Accessibility Evaluation

Monroe County Polling Location

St. John's Catholic Church
4607 W State Rd 46
Bloomington, IN 47404

Report Date: 04/10/2026

Finding: 1

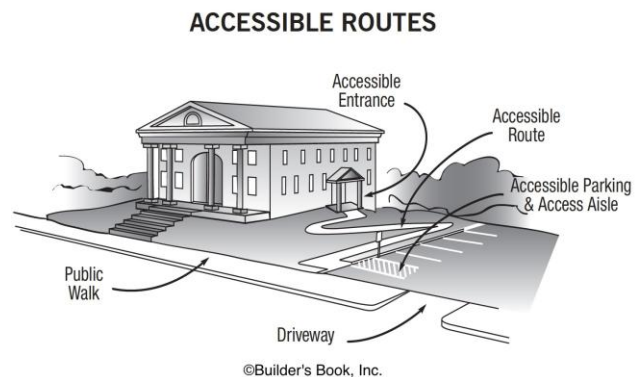
The access aisle is not located on an accessible route of travel to the accessible building entrance.

Accessible parking spaces serving a particular building shall be located on the shortest accessible route of travel from parking to an accessible entrance. In buildings with multiple accessible entrances with adjacent parking, accessible parking spaces shall be dispersed and located closest to the accessible entrances.

Access aisles serving parking spaces shall comply with 502.3. Access aisles shall adjoin an accessible route. Two parking spaces shall be permitted to share a common access aisle.

No curb cuts at access aisles. Recommend either adding ramps up to sidewalk or using cones to mark a protected path of travel from the parking lot to the portico.
